September 2019  
SF591A-D

## Subject: Wabco HP Air Dryer Turbo Cut-off Valve

**Models Affected:** Specific Model years 2019-2020 Freightliner 122SD, Cascadia, Western Star 4900, 5700, and 6900 manufactured March 6, 2018, through June 7, 2019, and equipped with a WABCO HP air dryer.

A revised turbo cut-off valve assembly will be installed and the signal line cleared of moisture.

**Fig. 2, Removing the Plastic Cover**

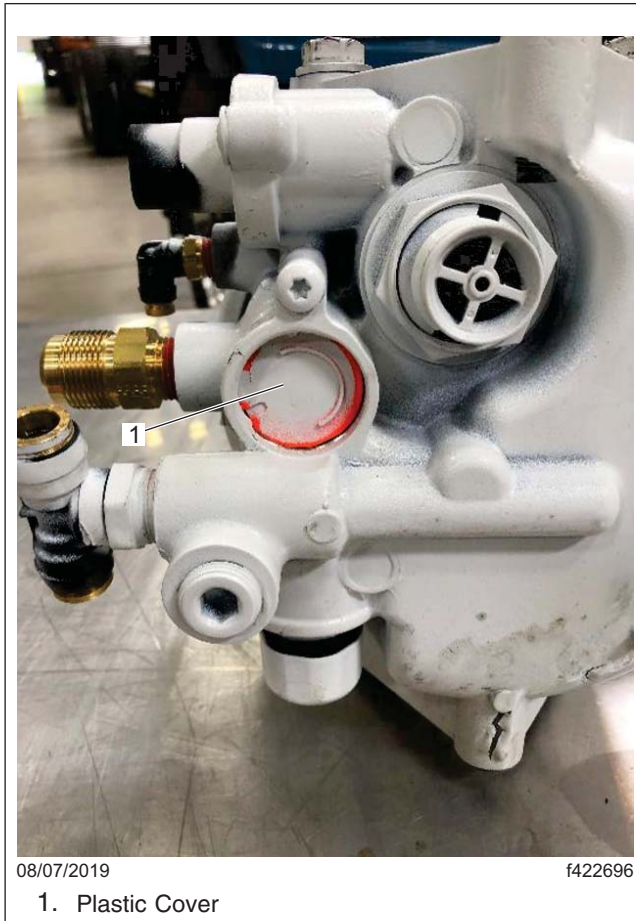
12. Remove the plastic cover (orange and white in color) from the turbo cut-off valve. See [Fig. 2](#) and [Fig. 3](#).

**Fig. 5, Applying Shop Air to Dislodge the Valve**

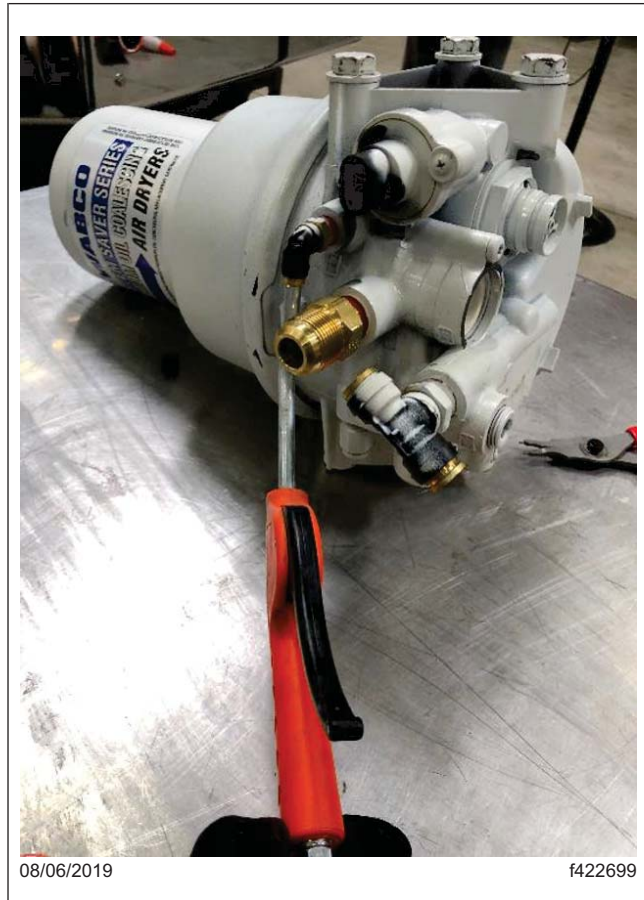
13. Install the snap ring. See [Fig. 4](#).
14. Using 15 psi (103 kPa) shop air through the signal port of the air dryer, dislodge the turbo cut-off valve. See [Fig. 5](#).

**Fig. 6, Snap Ring is Removed a Second Time**

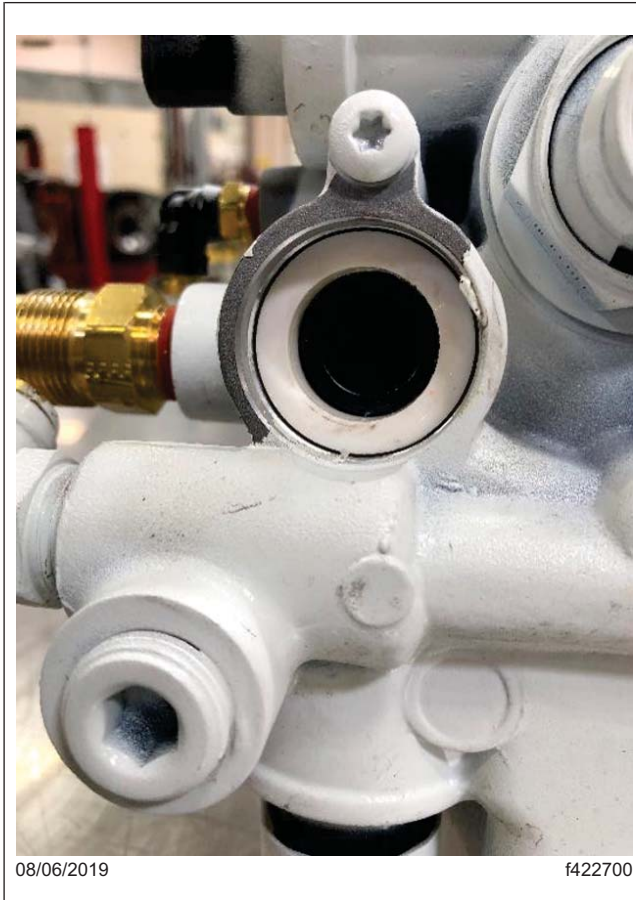
15. Remove the snap ring again. See [Fig. 6](#)
16. Remove and discard the turbo cut off valve. See [Fig. 7](#) for an example of the valve.

**Fig. 9, Snap Ring and New Valve Installed on the Air Dryer**

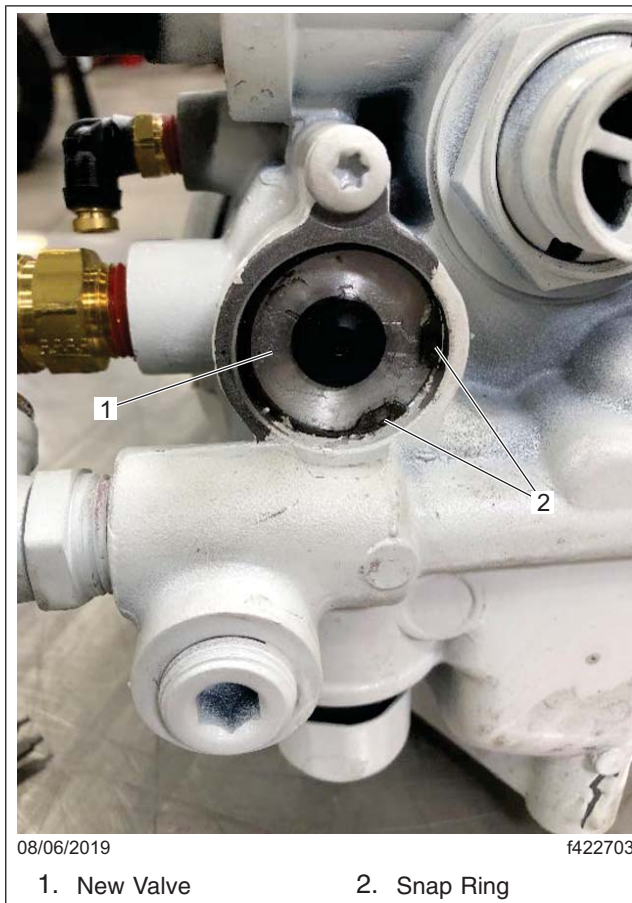
19. Install the new turbo cut-off valve on the air dryer. See [Fig. 8](#) for an example of the valve.
20. Install the snap ring. See [Fig. 9](#).
